North Anna 3 COLA

Slides for Discussion with NRC
Response to NRC March 9, 2016
Question 1 (Follow-up to RAI 04.02-1)

March 10, 2016

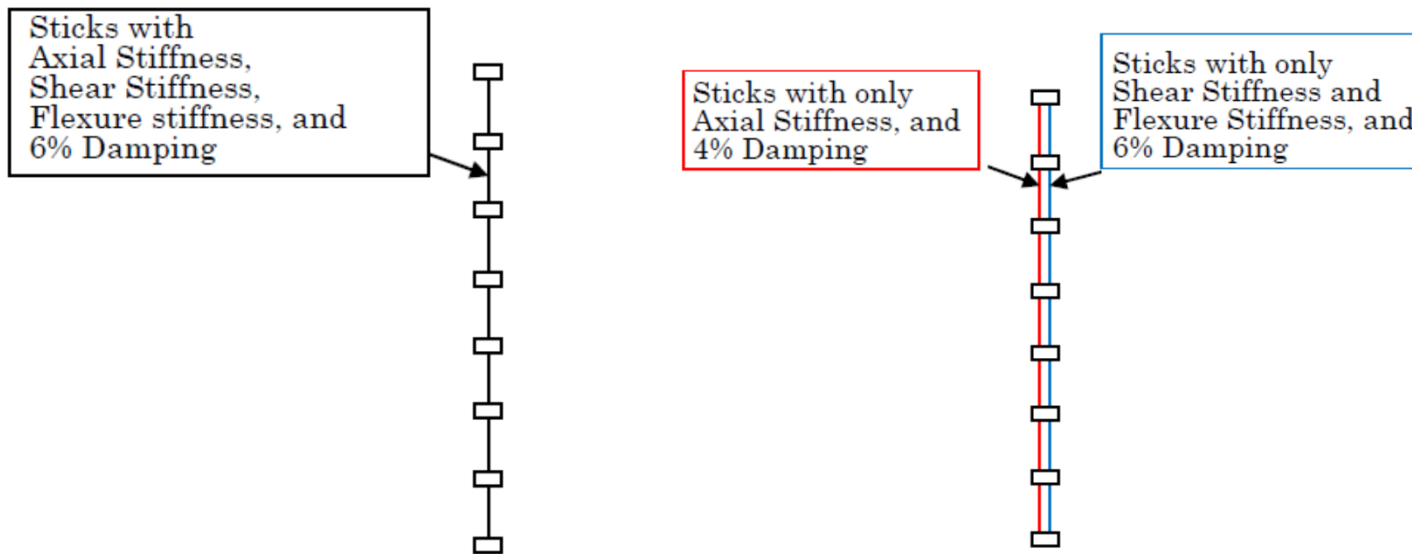
The response to RAI 04.02-1 includes a reference to WG3-002N9544, which is a North Anna Unit 3 site-specific analysis supplement to topical report NEDC-33240P-A. This supplement includes a reference to SER-DMN-019, Shimizu Engineering Report, “GE Hitachi Nuclear Energy, Dominion NA3 ESBWR Project, RB/FB Seismic Analyses Bounding Results and In-Structure Response Spectra”. The staff reviewed this reference and noted that the finite element analysis model for the fuel assemblies differs from the model used in the referenced approved methodology as presented in NEDC-21175-3-P-A.

Identify any differences between the finite element analysis model used in the North Anna Unit 3 site-specific analysis and the finite element analysis model used in the referenced methodology, NEDC-21175-3-P-A. Provide justification for these deviations.

- The NA3 RPV structural model in SER-DMN-019 of which the fuel assemblies are part is identical to the DCD RPV model (nodes 801 – 872) in DCD Fig. 3A.7-4. RB/FB Complex Seismic Model. The exception was the need to include OBE damping for site specific analysis see subsequent slide from 11/19/2014 NRC presentation
- NEDE 21175-3-P-A model is used for fuel lift only
 - Fuel lift analysis has not been done for the GE14E fuel
 - ITAAC Table 2.1.1-3 Item 15 requires that the initial fuel to be loaded in to the core will be able to withstand fuel lift and seismic and dynamic loads under normal operation and design basis conditions
- NRC FSER agreed with the fuel seismic/dynamic approach (slide 7)

- RB/FB standard design dynamic model is modified in order to enable modeling of different OBE damping values for the fuel in horizontal and vertical direction
 - Two sets of stick elements are used for fuel in RB/FB LMSM providing separate representations of fuel axial and flexure stiffness
